Access Compliance Report

# Public Rights-of-Way
(Curb Ramps)

Intersection ID: 52583	**Main Street: NEW_RENAISSANCE_WY**	**Cross Street: N/A**	**Location: N**
ADA ID: 1578A6219201	**Ramp Type: Perp**	**Initial Pass/Fail: Fail**	**Overall Compliance: No** **Severity Score: 12.5**

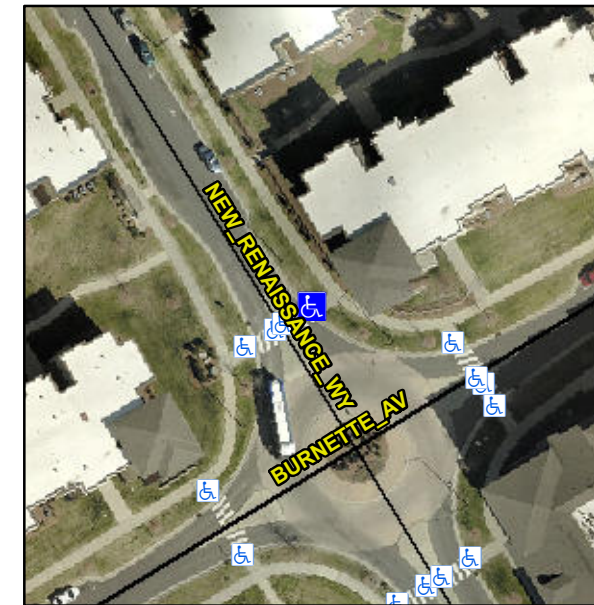
Not Found, R304.2.2

Compliance	Description	Data	Compliance	Description	Data
N/A	Ramp Length (in)	66.0	No	Ramp Slope (%)	9.5
Yes	Ramp Width (in)	70.0	Yes	Ramp XSlope (%)	0.8
N/A	Flare Type LT	N/A	N/A	Flare Type RT	N/A
N/A	Flare Slope LT (%)	N/A	N/A	Flare Slope RT (%)	N/A
N/A	Flare Traversable LT?	N/A	N/A	Flare Traversable RT?	N/A
N/A	Landing Length (in)	N/A	N/A	DWS Provided?	N/A
N/A	Landing Width (in)	N/A	N/A	DWS Contrast?	N/A
N/A	Landing Slope (%)	N/A	N/A	DWS Length (in)	N/A
N/A	Landing X Slope (%)	N/A	N/A	DWS Full Width?	N/A
N/A	Landing Curb? (Y/N)	N/A	N/A	DWS Offset (in)	N/A
N/A	Shared Landing?	N/A			
N/A	Gutter Ponding?	N/A	N/A	Gutter Slope (%)	N/A
N/A	Gutter Lip Ht (in)	N/A	N/A	Gutter X Slope (%)	N/A
N/A	Painted X Walk1?	Yes	N/A	Painted X Walk2?	N/A
	X Walk 1 Direction	To W		X Walk 2 Direction	N/A
N/A	X Walk 1 Width (in)	123.0	N/A	X Walk 2 Width (in)	N/A
	X Walk 1 Slope (%)	0.5		X Walk 2 Slope (%)	N/A
	X Walk 1 X Slope (%)	1.2		X Walk 2 X Slope (%)	N/A

Remove & Replace Entire Ramp.
